**TOTAL MAXIMUM DAILY LOAD (TMDL)**

**Middle Rio Grande Watershed**

**JUNE 30, 2010**

**APPENDIX E**  
**RESPONSE TO COMMENTS**

**Figure 2.7 Daily Mean Streamflow: USGS 08329928 - Rio Grande near Alameda**

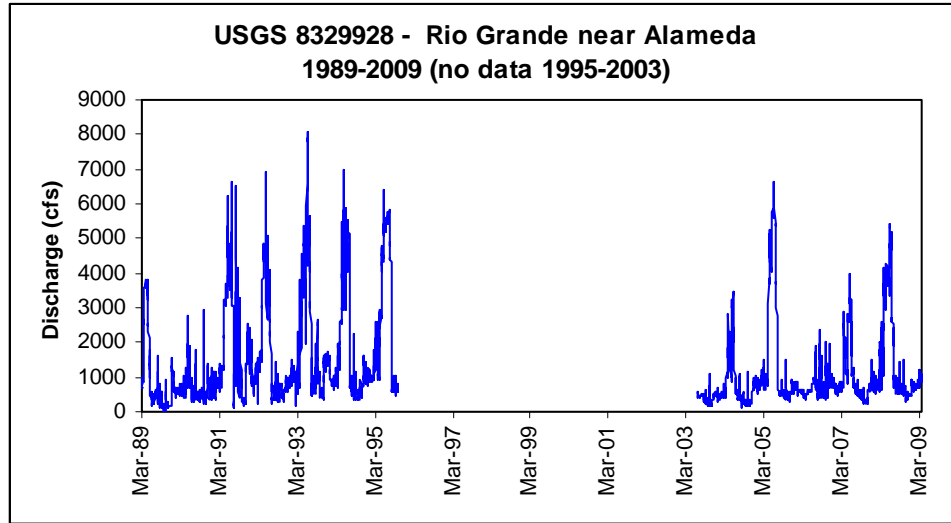
- In Table 2.3 of Section 2.4.2 on Page 13, please indicate which of the listed USGS gages were used to determine streamflows in TMDL calculations.
- In Figure 2.7 of Section 2.4.2 on Page 15, there is a nearly 10-year gap in streamflow data. We are concerned about the reliability of the streamflow data used for TMDL calculations in this assessment unit. Please add language addressing this concern.

**SWQB Response:** *Table 2.3 is included in order to present all active gages in the MRG area; Figures 2.4-2.7 represent the flow for the four USGS gages used in the load duration curves in the TMDL. SWQB has confirmed with USGS staff that there is no flow data available for USGS Gage 08329928 from October 1995 to June 2003 due to lack of funding for data collection at that site. According to An Approach for Using Load Duration Curves in the Development of TMDLs (USEPA, 2007),*

**Figure 3.1 USGS 08358400 Rio Grande Floodway at San Marcial, NM (1974-2009)**

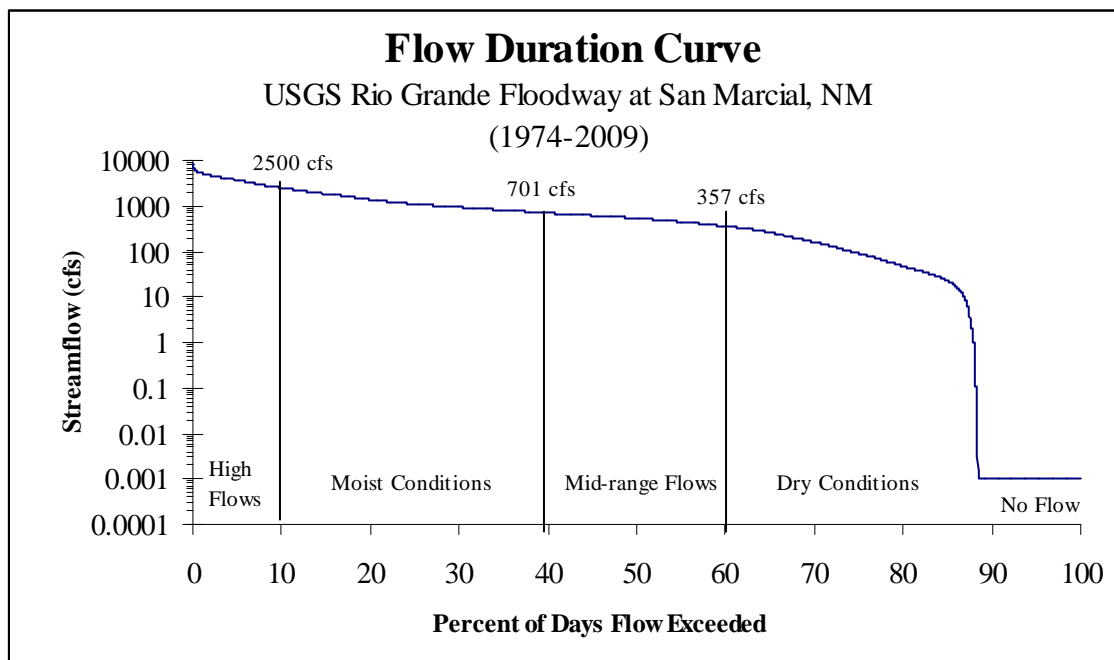
- In Figure 3.1 of Section 3.2 on Page 17, please identify the USGS gage by number in the figure. In addition, the term “moist conditions” is a misnomer for conditions in which streamflow exceeds the “mid-range flows” condition. Perhaps the terms “moist conditions” and “mid-range flows” can be reversed throughout the TMDL document for better reader understanding.
- In the second paragraph on Page 17, it will be helpful to include a more detailed explanation of the computational method used to produce the Aluminum Load Duration Curve in Figure 3.2 on Page 18. Assuming that the Aluminum Loading Duration Curve (Figure 3.2) was produced with values from the Flow Duration Curve (Figure 3.1) and a water quality standard for aluminum from 20.6.4.900 NMAC, please indicate whether the acute or the chronic WQS for dissolved aluminum was used in the calculations.

**Figure 3.1 Flow Duration Curve;** *USGS Rio Grande Floodway at San Marcial, New Mexico 1974-2009 (Page 17) - For categories of the flow duration analysis, the two classifications of moist conditions and dry conditions should be changed. A flow duration curve does not relate to dry and wet (or moist) years. The correct terminology is high or low flows.*

**SWQB Response:** *The USGS Gage number was added to the title of Figure 3.1. SWQB staff attended a training with Bruce Cleland and EPA R6 in February 2007. The development of the flow and load duration curves in this TMDL was based on this training as well as a research article by Bruce Cleland and guidance from the EPA Office of Wetlands, Oceans, and Watersheds. The use of “moist” and “mid-range” in the TMDL is consistent with the literature research. Language was added to Section 3.2 regarding the use of the chronic dissolved aluminum WQS in the development of the load duration curve. References to the EPA document have been added to Section 3.2 as well as Section 9.0. The Cleland (2003) reference remains in Section 3.2. Both references provide detailed explanations of both flow and load duration curve development.*

Figure 4.4 Flow Duration Curve: USGS 08329928 Rio Grande near Alameda, NM

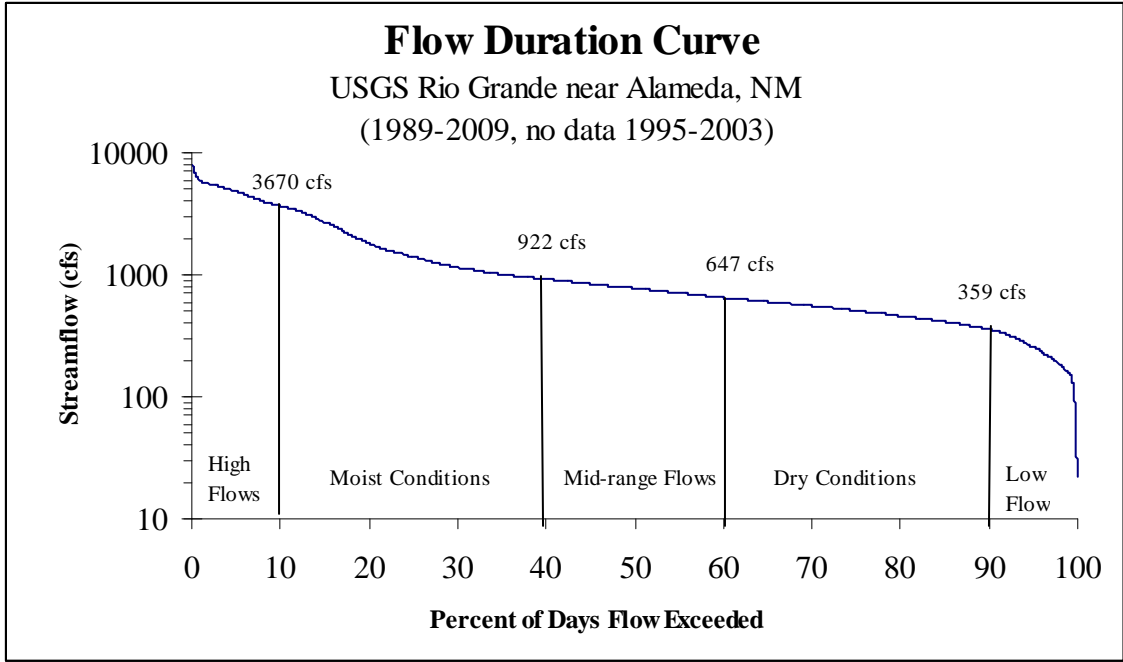
Finally, an even closer examination of the data suggests a possible error in NMED's analysis. Reference to Figure 4.8 in the draft TMDL document shows a sequence of samples collected under very low flow conditions,  $Q < 359$  cfs. However, according to USGS data, the lowest daily average flows measured at the Alameda Bridge during any of the sampling events was 383 cfs on 10/26/5. Use of erroneously low flow values will result in correspondingly low loads. The NMED should explain the source of flow data used in their load calculations.

*As displayed in Figure 2.7 and Figure 4.4, USGS gage 08329928 was used for the development of the flow and load duration curves. The flow at the Rio Grande near Alameda (08329928) USGS gage was 299 cfs on 10/26/2005. Figure E.1 displays the data downloaded from the USGS website for this gage and date. AMAFCA correctly notes the discharge from USGS gage 08329918 (Rio Grande at Alameda Bridge) was 383 cfs on 10/26/2005. The title of Figure 4.4 has been edited to clarify which USGS gage data was used.*

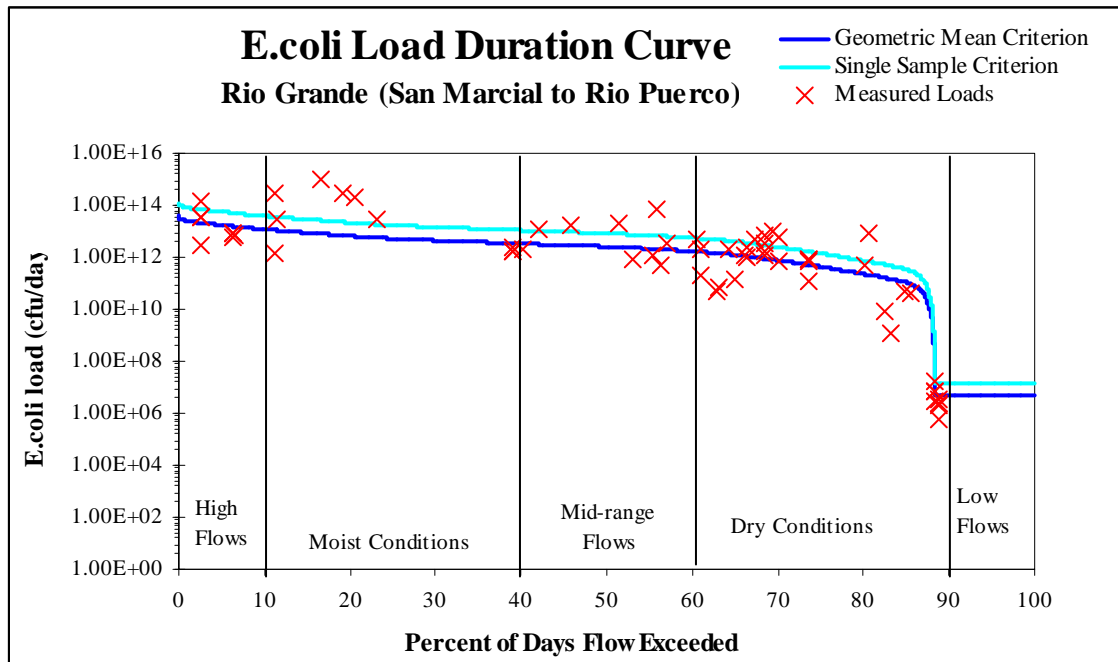
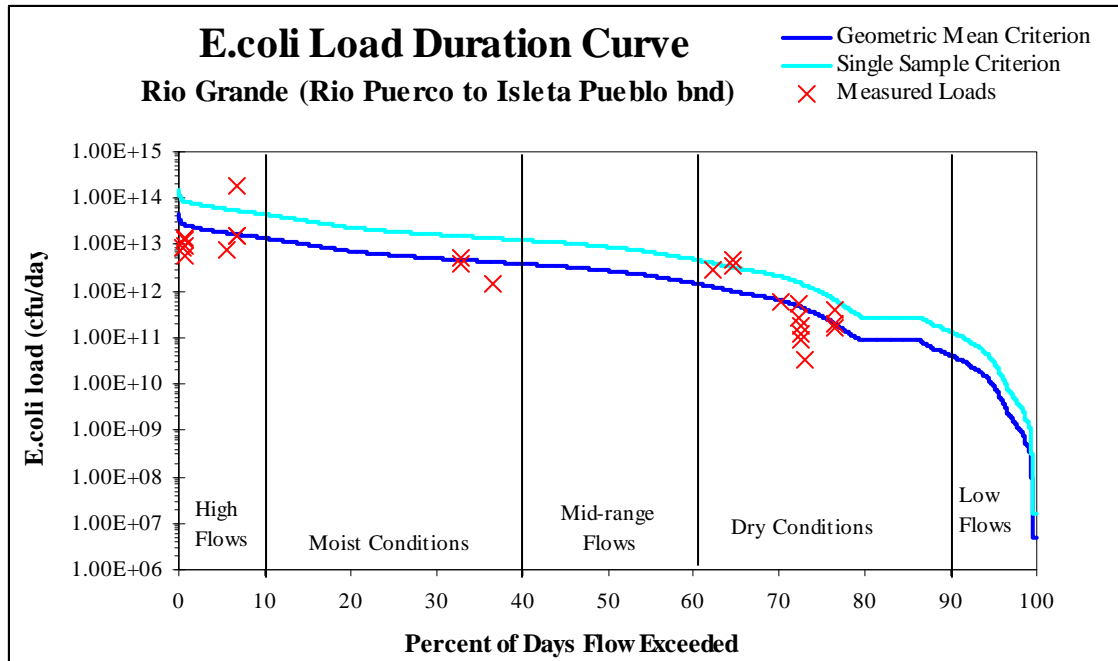
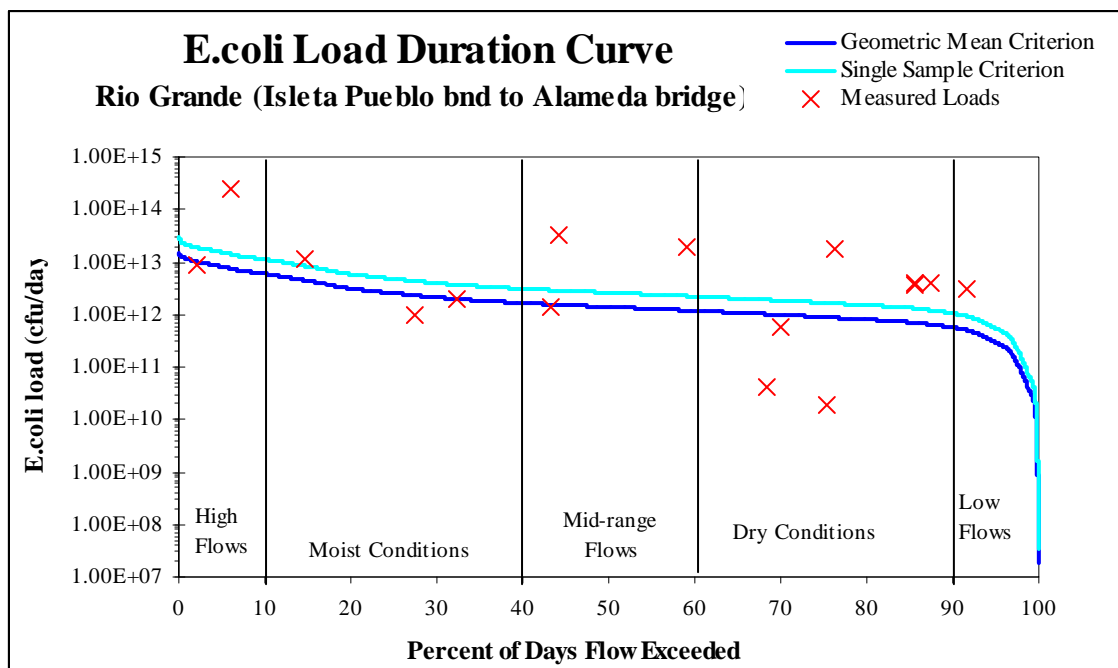
- **Section 4.2 Flow (for bacteria)**
  - For Figures 4.5 - 4.7 in Section 4.2 on Pages 31-33, a more detailed explanation of the methodology used to produce the criterion curves would be helpful. (The last paragraph on Page 33 provides a good starting point.)

**Figure 4.8** *E. coli* Load Duration Curve–Rio Grande (non-Pueblo Alameda bridge to Angostura)

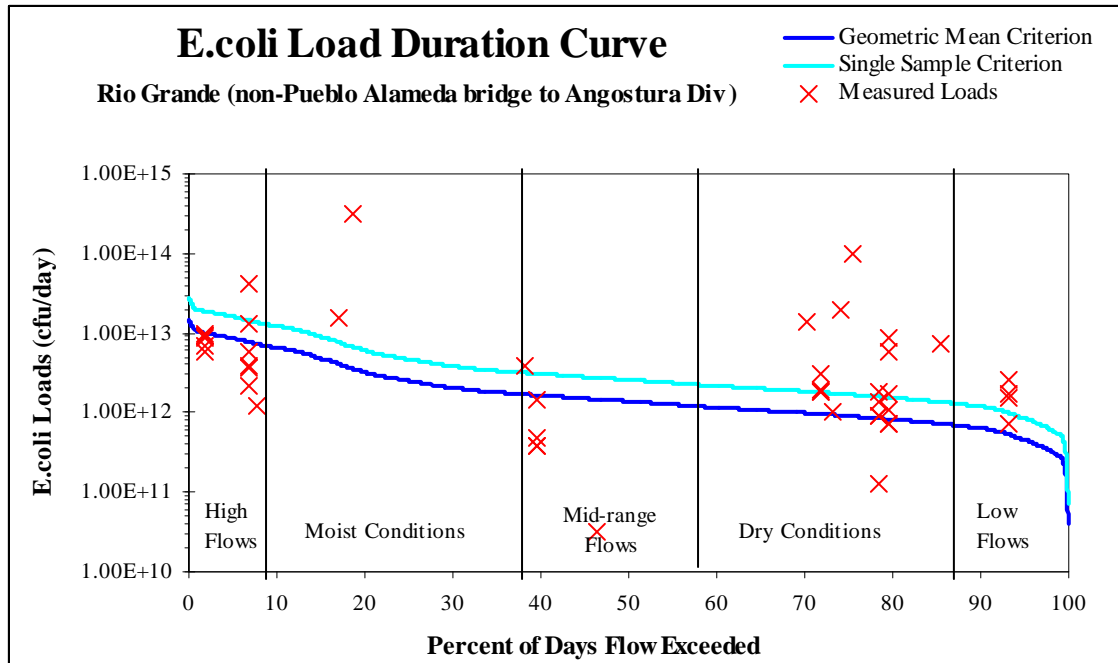
Our most strident objection to the TMDL deals with the lack of recognition of natural sources of E coli bacteria in the river. Figure 4.8 in the TMDL appears to show that the highest exceedance of the stream standard for E coli above the Alameda Bridge occurs during low flow conditions. The document attributes high concentrations of E coli under low flow conditions to point sources (page 21).

*This statement is included as a general statement related to load duration curves. Figure 4.8 shows exceedences of both the single sample and geometric mean criterion across most flow regimes. The TMDL does not negate the non-point source contribution of E.coli bacteria nor does it attempt to explain each E.coli exceedence noted in the water quality monitoring data. The fact that these data seem to contradict a general rule of load duration curve interpretation is an issue to be addressed during permit implementation.*
